City Council, April 25, 2013
Agenda Item #70

Motion #1: Adopting the Sept. 14, 2012 Draft ERC Regulating Plan with amendments as follows:

SUMMARY SHEET

March 7, 2013 Approved Amendments to the Sept. 14, 2012 Draft ERC Regulating Plan

Figure 1-3: East Riverside Corridor Roadway Type Map

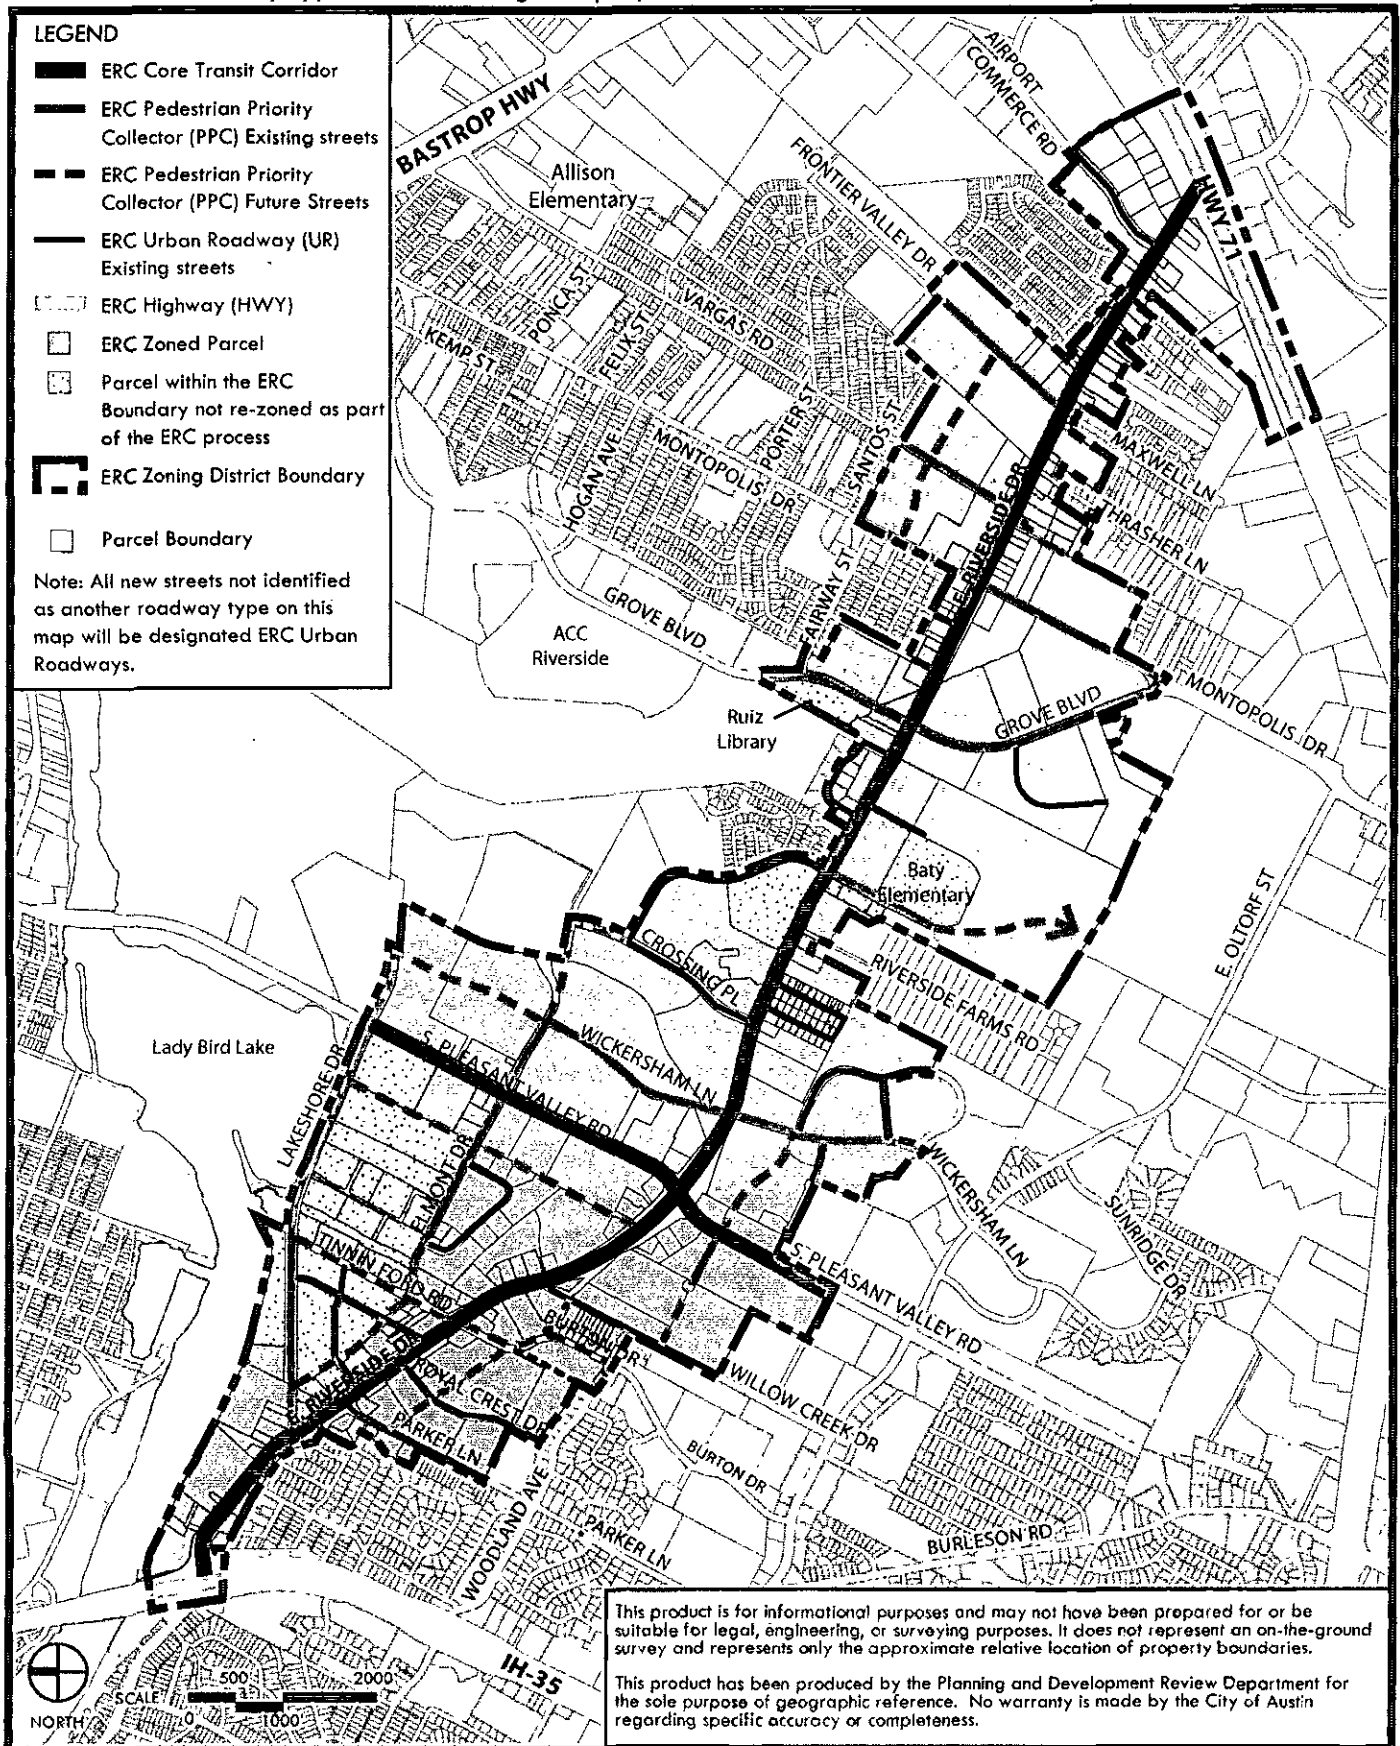
- C.2. P. 15, Modification to collector street map to account for an existing drainage way. See revised Figure 1-5: East Riverside Corridor Collector Street Map (Nov. 8, 2012 DRAFT – see attached) and associated Figure 1-3: East Riverside Corridor Roadway Type Map (Nov. 8, 2012 DRAFT– see attached).

Figure 1-14: East Riverside Corridor (ERC) Future Land Use Map (FLUM)

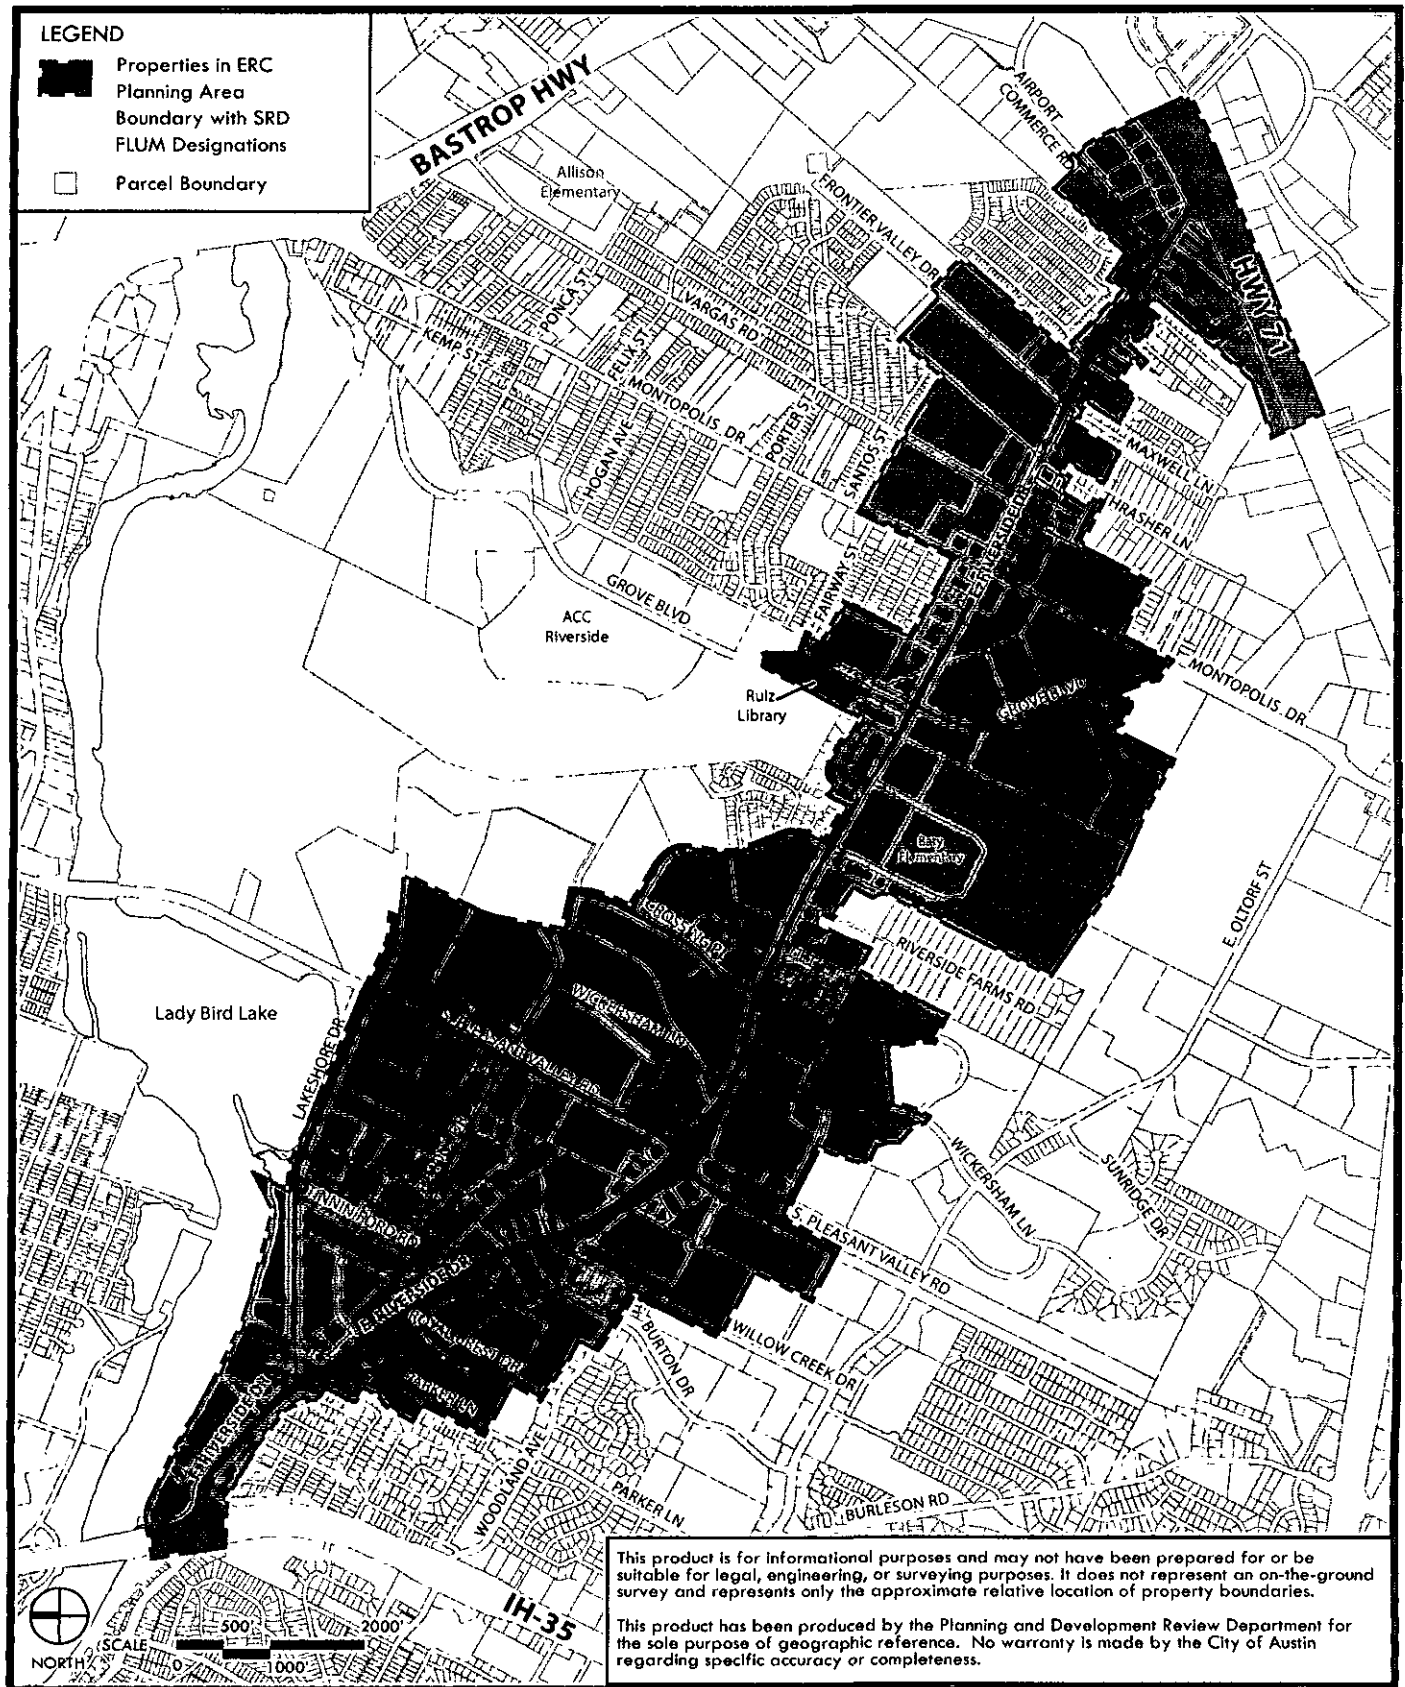
- A.3. P. 24. Add new Figure 1-14: East Riverside Corridor (ERC) Future Land Use Map (Nov. 8, 2012 DRAFT – see attached) (**Note:** Added for clarification purposes.)

Figure 1-15: Map of Properties with Drive-Through Facilities as of [adoption date, 2013].
 Map of properties to which Subsection 2.3.5.8 (Drive-Through Facilities) applies.

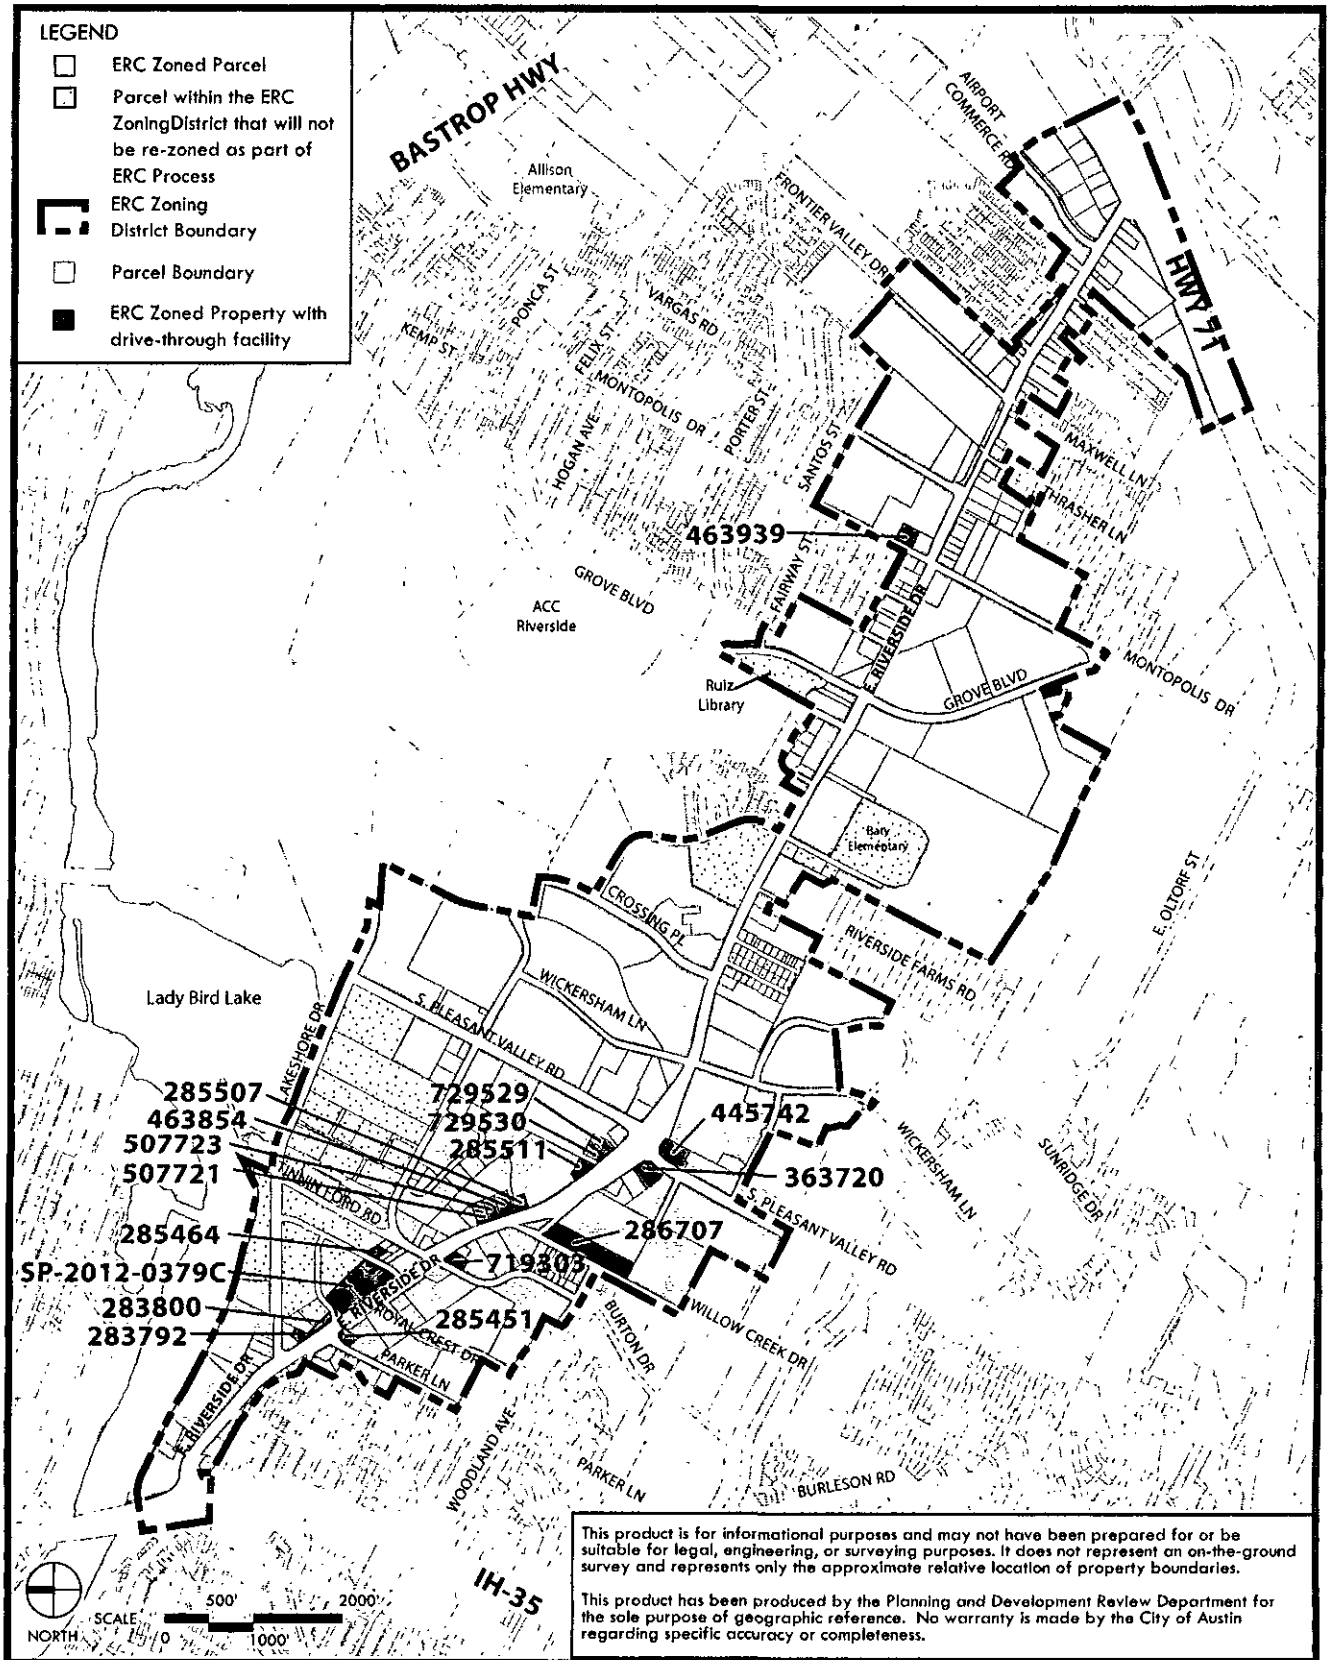
- D.1 P. 27, Subsection 2.3.5.B (Drive-Through Facilities) – Delete the text of Subsection B and replace with the following: “A property containing a drive-through facility legally constructed or permitted prior to [insert ERC Regulating Plan adoption date], is not subject to this Subsection 2.3.5.A. Construction on said properties can include the replacement of a drive-through facility, but construction will be subject to all standards in the ERC Regulating Plan according to the applicability standards in Section 1.2 Applicability. The number of drive-through bays or lanes cannot be increased from those existing as of the above date.” (**Note:** Staff deemed the original Subsection B language section repetitive and unnecessary.)
